Town of Fraser Land Use Application Referral Summary

Project Name: Grand Park West Mountain Filing 1 (Planning Area 10W & 11W) – Final Plat & FPDP

Project Number: TF22-10

RE: Grand Park West Mountain Filing 1 (Planning Area 10W & 11W) – Final Plat & FPDP (TF22-10)
7th Submittal Referral Summary and Planning Review

LAND USE PLAN

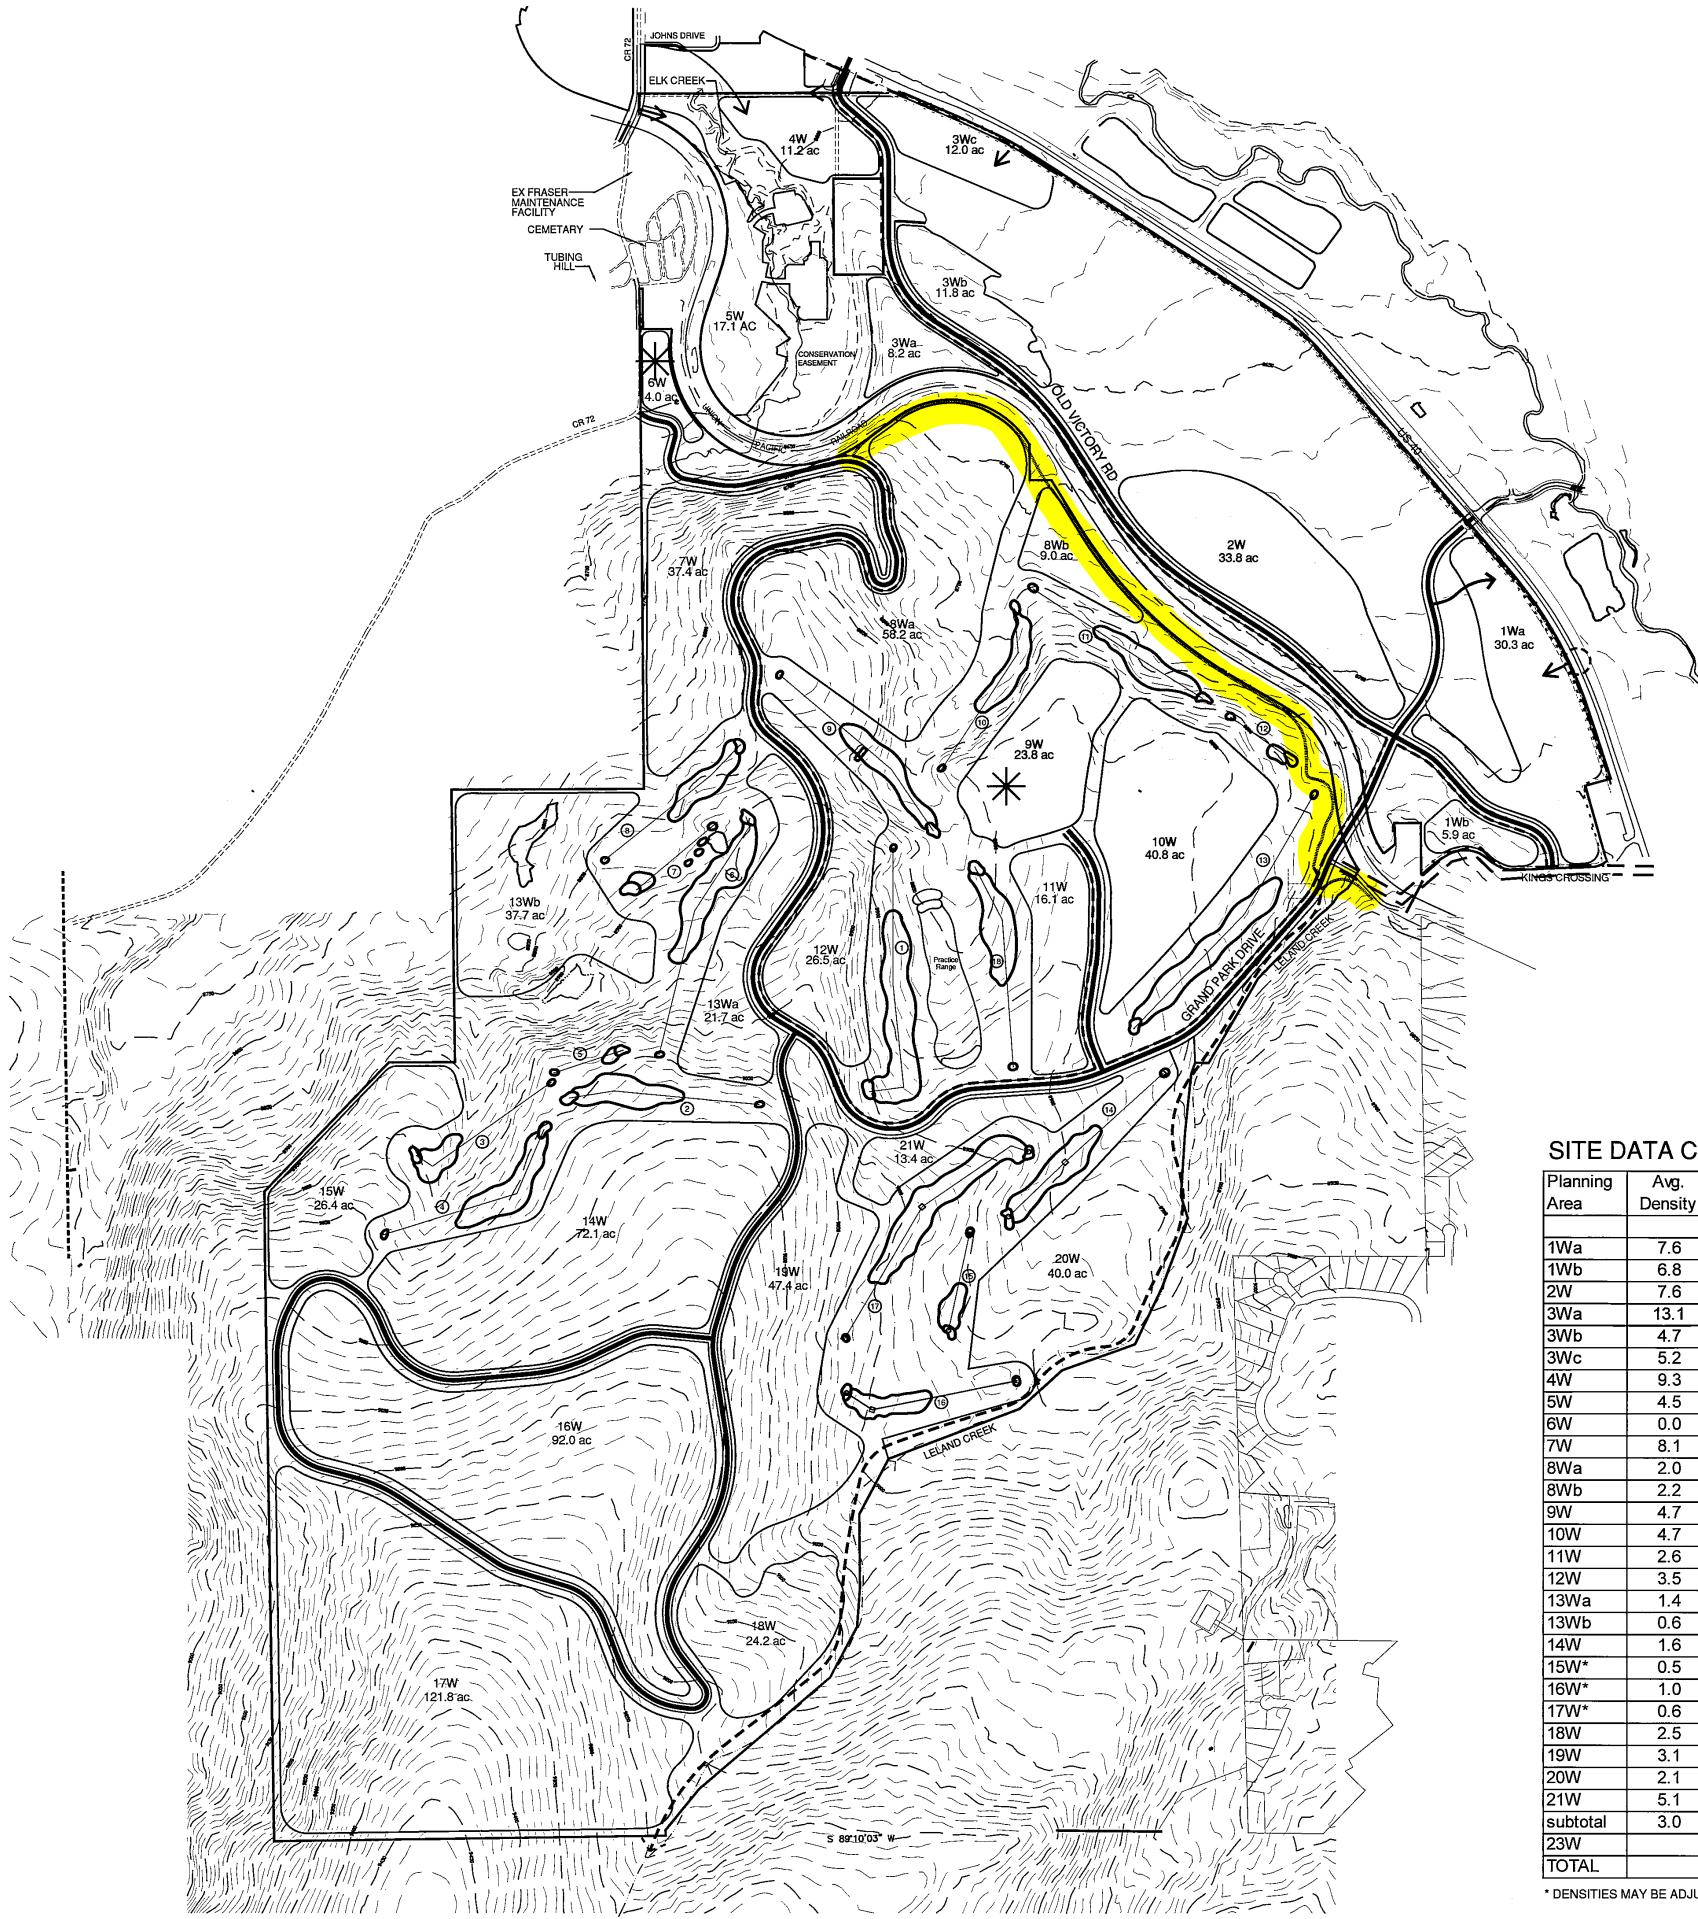
this appears to be a
regional or community
trail
